Case Number: H2025-003

Walker Residence
603 E Rusk Street
Abstract No. 14
B.F. Boydston Survey
City of Rockwall, Rockwall County, Texas

HISTORIC PRESERVATION ADVISORY BOARD CASE MEMO

CASE NUMBER: H2025-003; Certificate of Appropriateness (COA) for an Addition at 603 E. Rusk Street

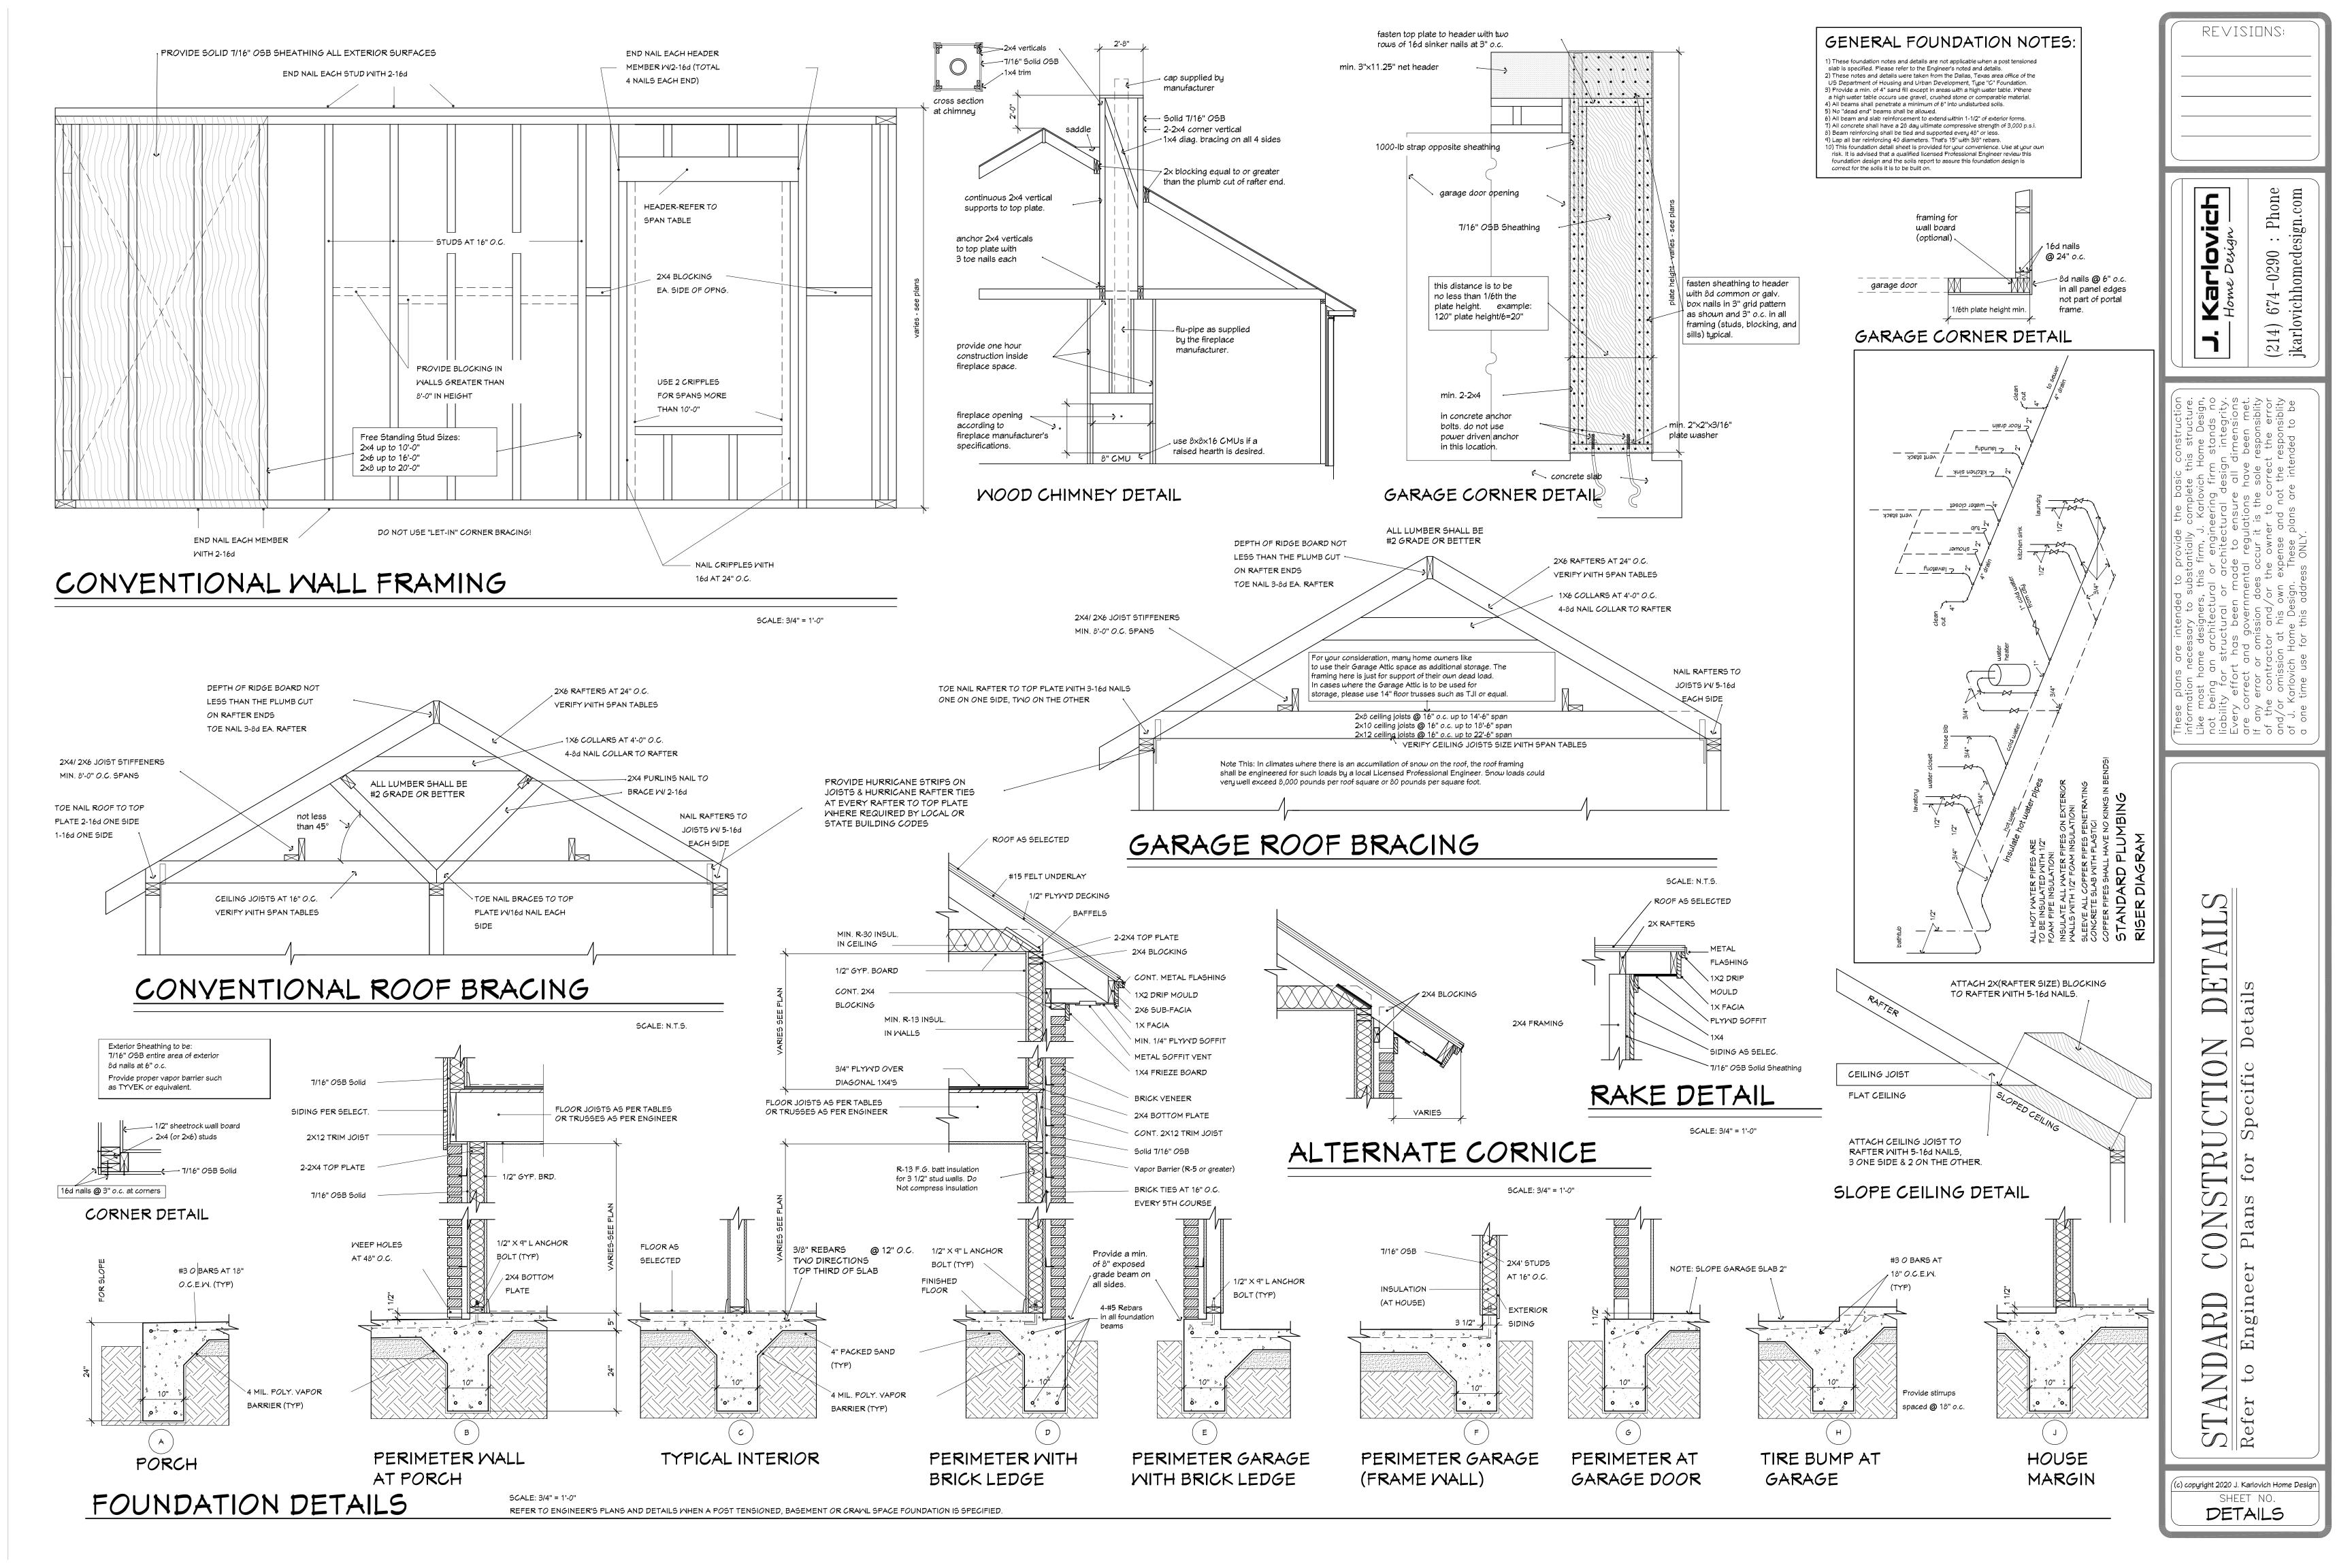
- (a) <u>Height.</u> According to Section 07(A), of Appendix D, *Historic Preservation Guidelines*, of the Unified Development Code (UDC), "(a)II new buildings and additions shall be constructed to a height and number of stories which are consistent and compatible with existing neighboring historic buildings or structures on the same block face." In this case, the proposed addition and the proposed garage will be lower than the existing single-family home and have a total height of 12-feet, 8-inches.

- (c) <u>Building Facades and Materials.</u> According to Section 07(C)(6), of Appendix D, Historic Preservation Guidelines, of the Unified Development Code (UDC), "(n)ew additions, alterations and new construction should be visually compatible with neighboring historic buildings or structures." Based on the building elevations and scope of work provided by the applicant, the exterior façade of the new addition will consist of the same material that the existing single-family home is faced with.

- (d) <u>Roofs.</u> According to Section 07(M), of Appendix D, *Historic Preservations Guidelines*, of the Unified Development Code (UDC), "(r)eplacement, addition, or alteration to an existing roof should have the same overhang as the existing roof." The code goes on to say "(t)he degree and direction of roof slope or pitch should be consistent with the style and period of the historic structure." In this case, the applicant's plans show a consistent roof pitch of 5:12 throughout the proposed addition.

- (1) The subject property's designation shall be changed from a Low Contributing Property to a Non-Contributing Property.
- (2) The applicant shall be required to receive the necessary building permit(s) prior to any construction on the subject property.
- (3) Any construction resulting from the approval of this request shall conform to the requirements set forth by the Unified Development Code (UDC), the International Building Code (IBC), the Rockwall Municipal Code of Ordinances, city adopted engineering and fire codes and with all other applicable regulatory requirements administered and/or enforced by the state and federal government.
